Sundry ID: 2706637

| Type of Submission: Notice of Intent | Type of Action: Plug and Abandonment |

HILCORP ENERGY COMPANY
FRPC 21 3
NOTICE OF INTENT TO PERMANENTLY ABANDON

CONDITIONS OF APPROVAL

FRPC 21 3 - PROPOSED P&A SCHEMATIC

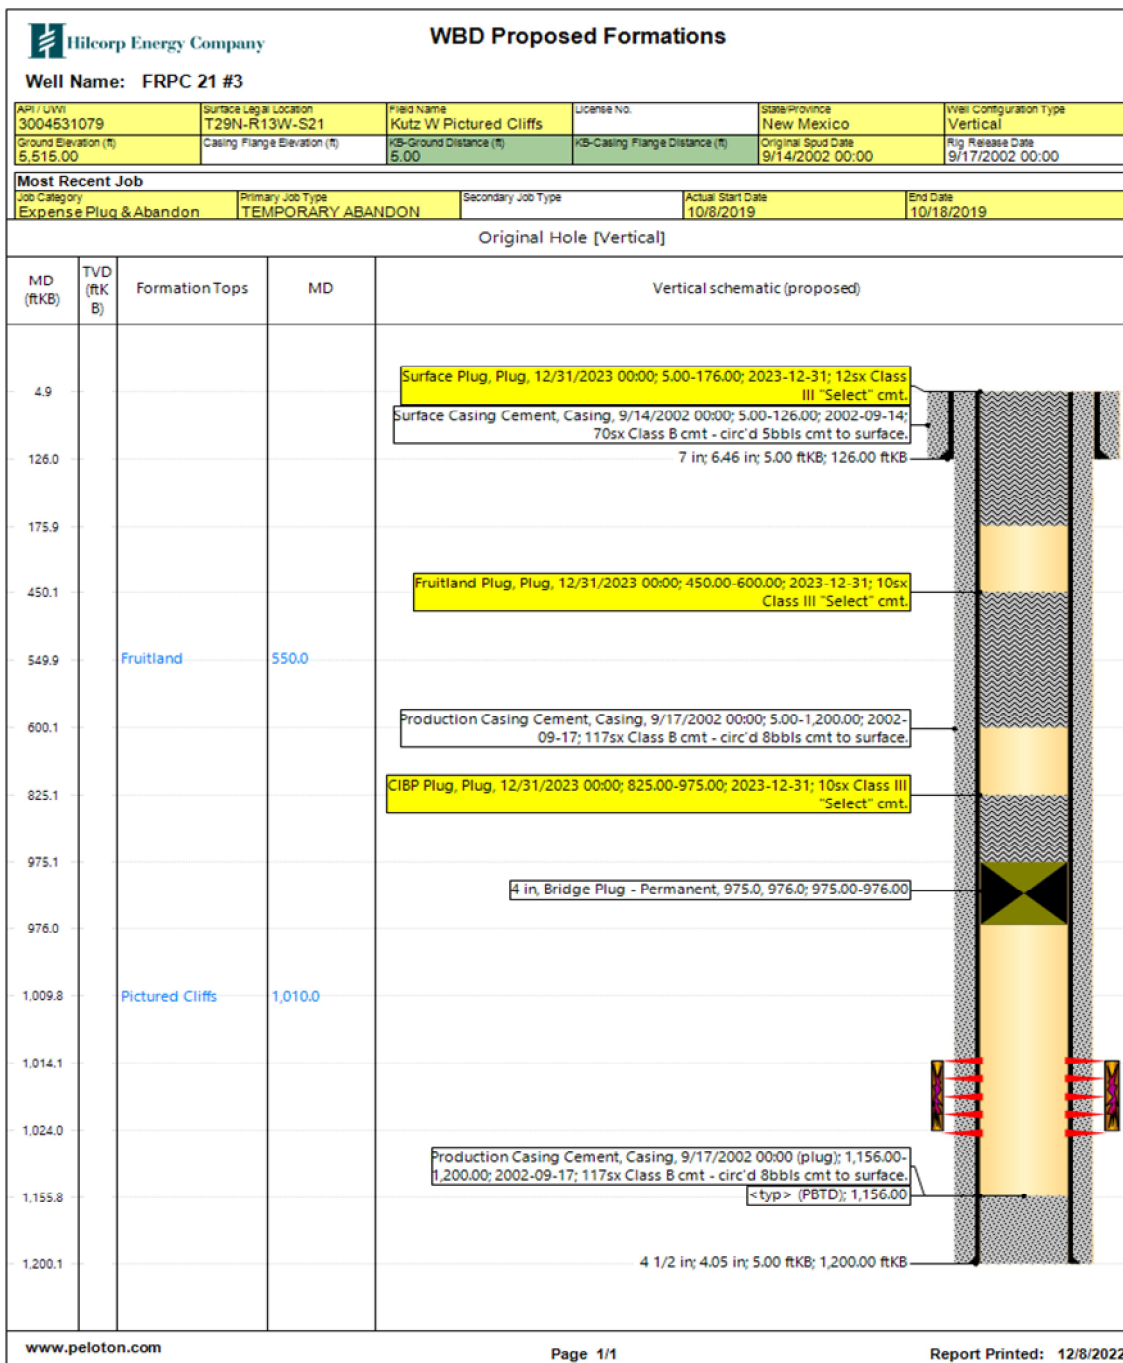
You are also required to place cement excesses per 4.2 and 4.4 of the attached General Requirements.
